HISTORIC AND DESIGN REVIEW COMMISSION

HDRC CASE NO: 2016-355
ADDRESS: 615 SOLEDAD ST
LEGAL DESCRIPTION: NCB 141 (MAIN & GIRAUD), BLOCK LOT 19
ZONING: D RIO-3
CITY COUNCIL DIST.: 1
APPLICANT: Beverly Schantz/LK Design Group, Inc
OWNER: Demetrios Macris/Soledad Realty, LTD
TYPE OF WORK: Final approval of exterior modifications
REQUEST:

The applicant is requesting a Certificate of Appropriateness to perform exterior modifications to the non-historic structure at 615 Soledad. The applicant has proposed the following:

PVA - SECOND FLOOR DEMOLITION PLAN

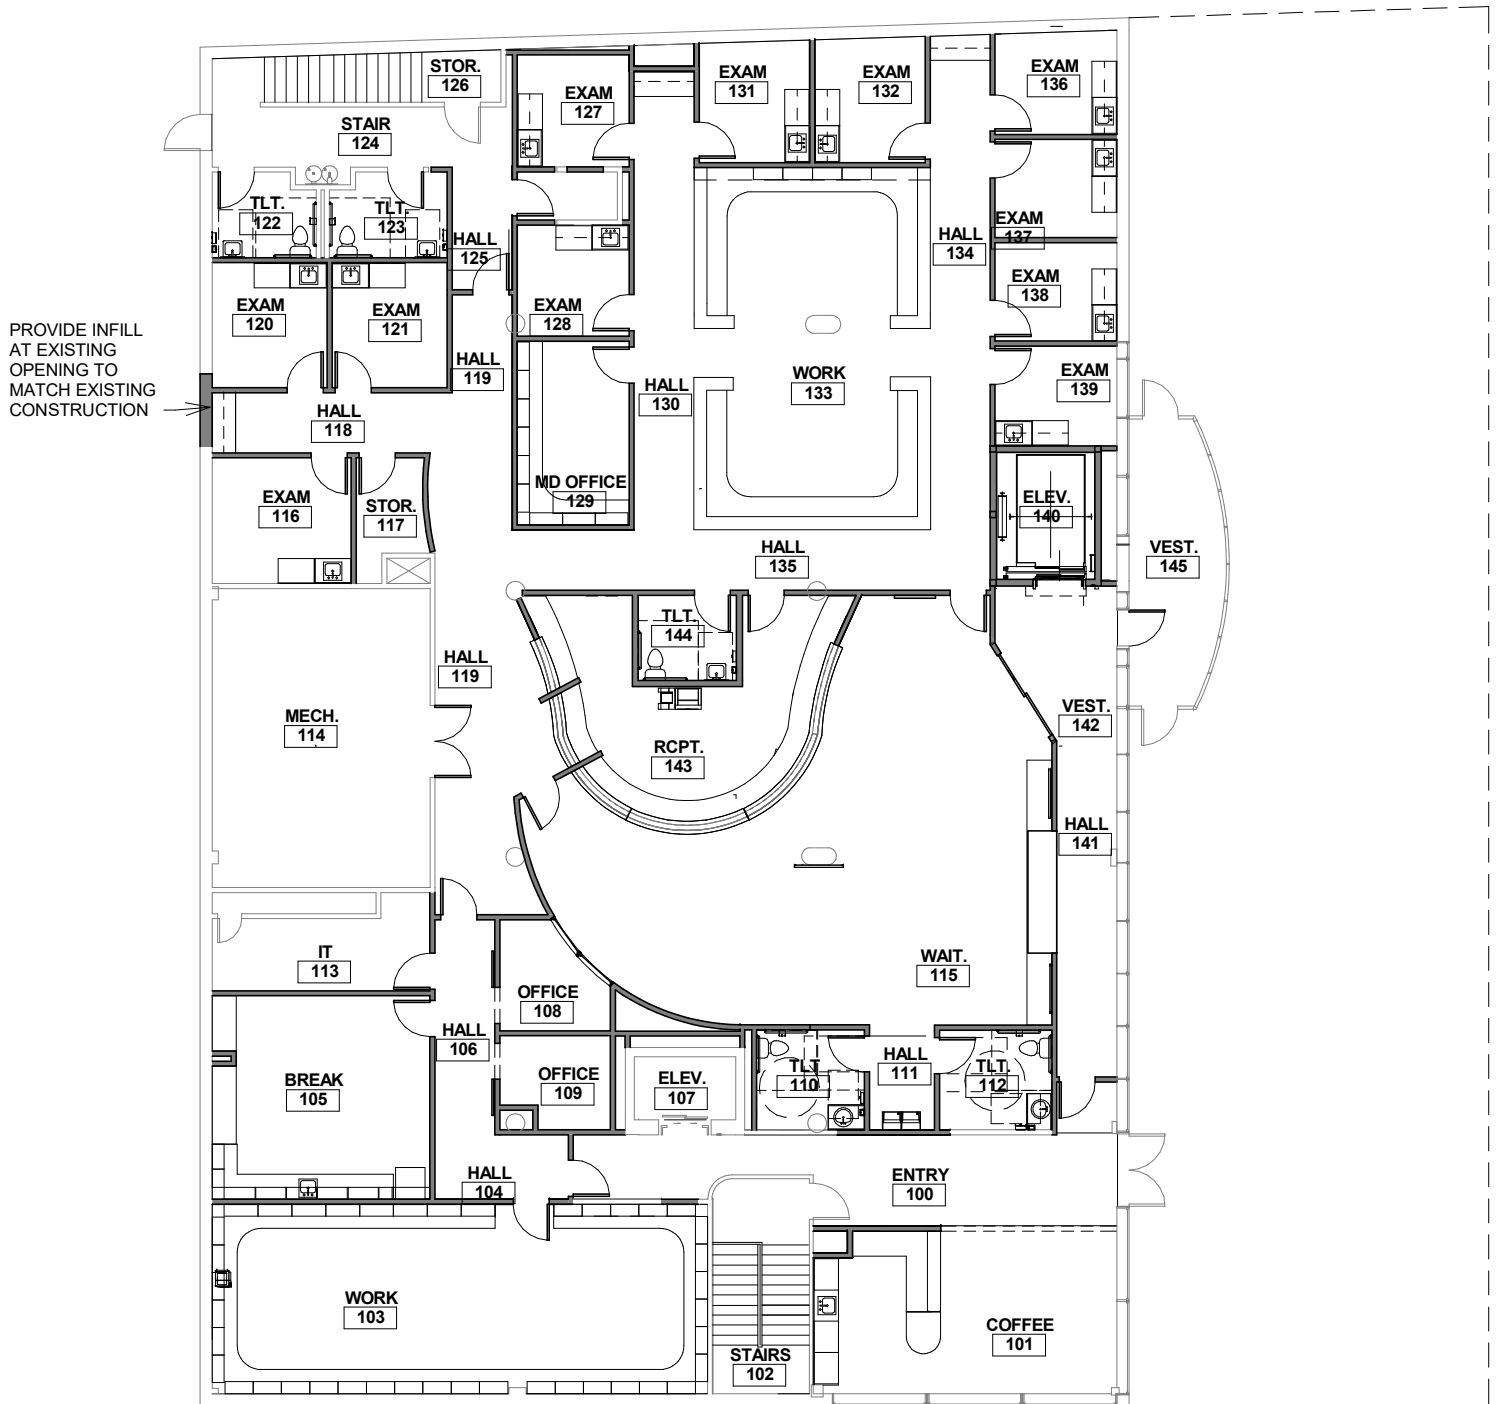
- b. The south façade currently features a second level patio and railing which the applicant has proposed to remove. While original to the structure, staff finds the removal of the patio and railing appropriate.

PVA - SOUTH ELEVATION

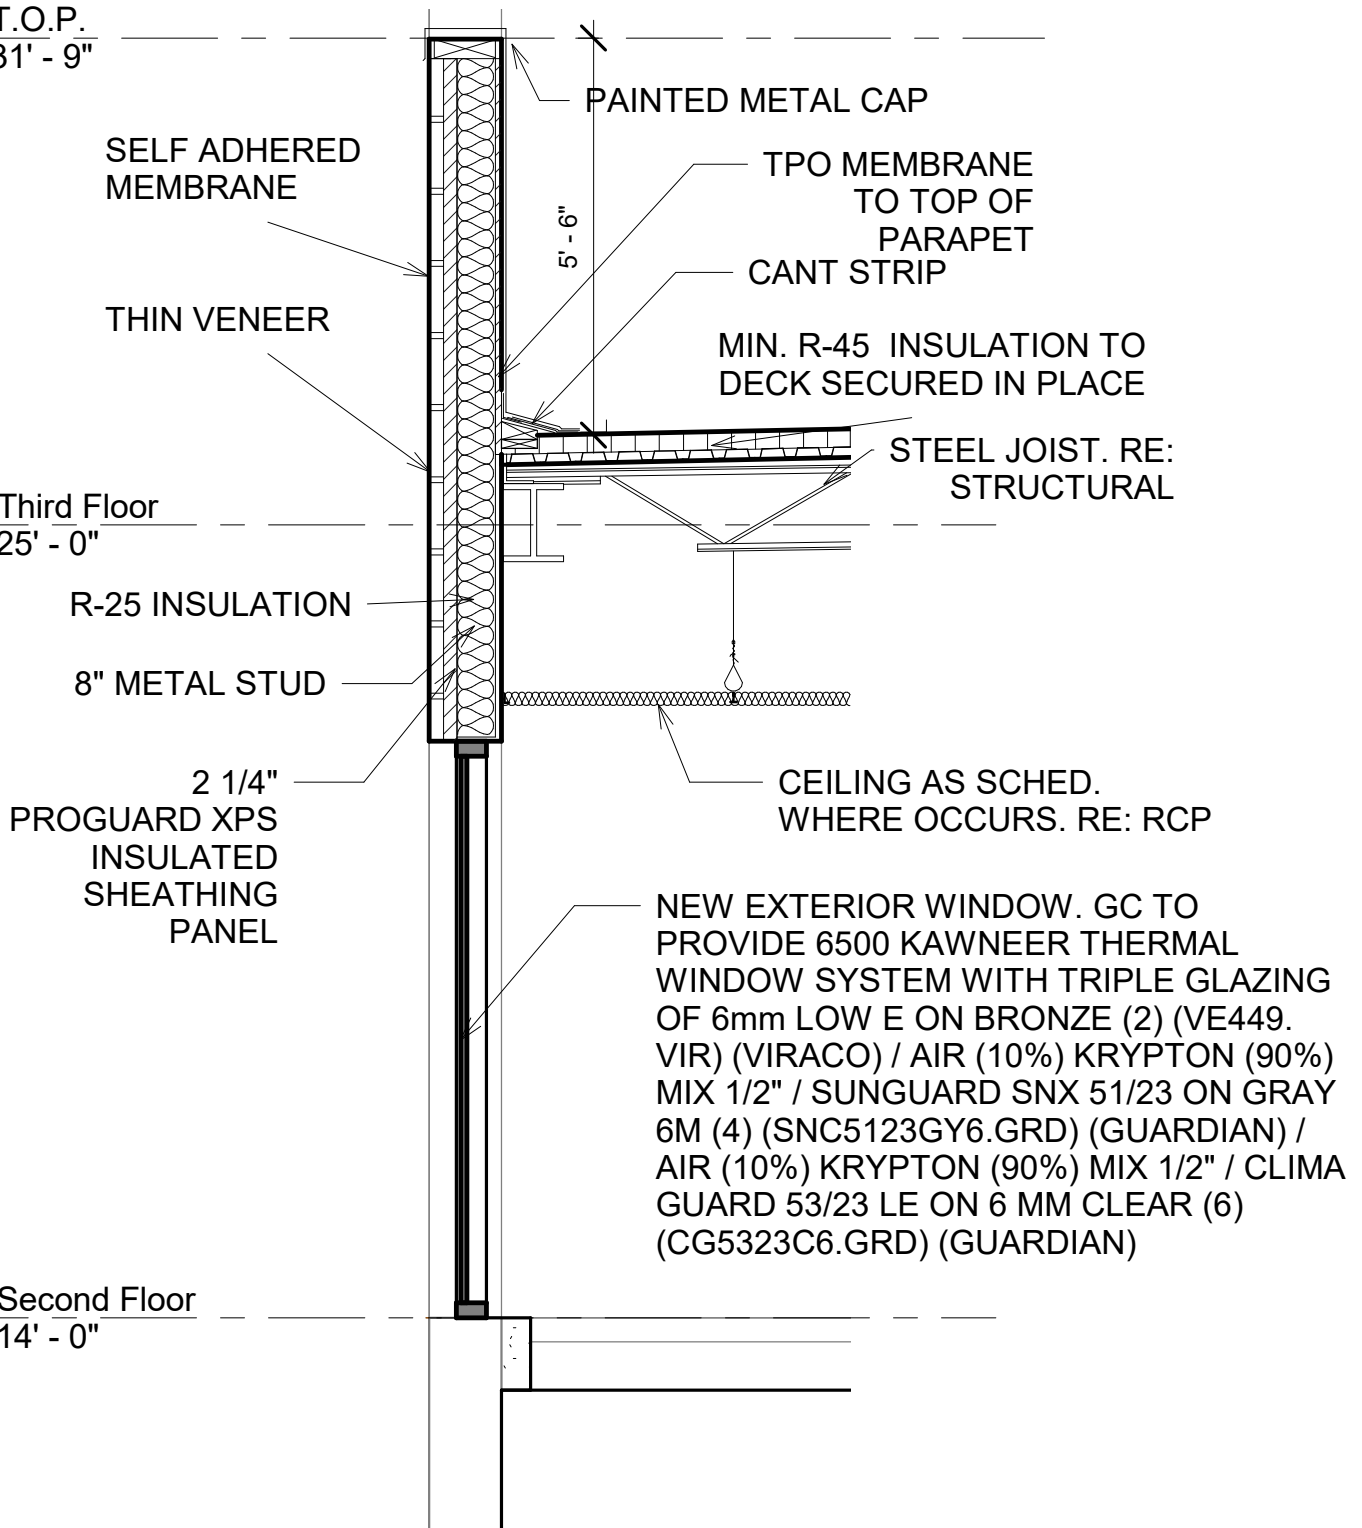
- c. Along the south façade, the applicant has proposed to enclose the previous open air patio on the second level. The applicant has proposed for the addition to feature massing that is subordinate to that of the original structure. The applicant has proposed materials that include a stone veneer to match the existing veneer as well as a new exterior glazing system and has provided detailed architectural documents to staff noting their installation. The applicant's proposed addition and materials are consistent with the UDC Section 35-674.

- d. The existing Giraud Street (south) façade features a set of double doors. The current opening features steel security doors. The applicant has proposed to enclose this existing opening. Staff finds the enclosing of this opening appropriate. Staff finds that the removal of this door will not negatively impact the architecture of the structure.

Staff recommends approval based on findings a through e with the following stipulation:
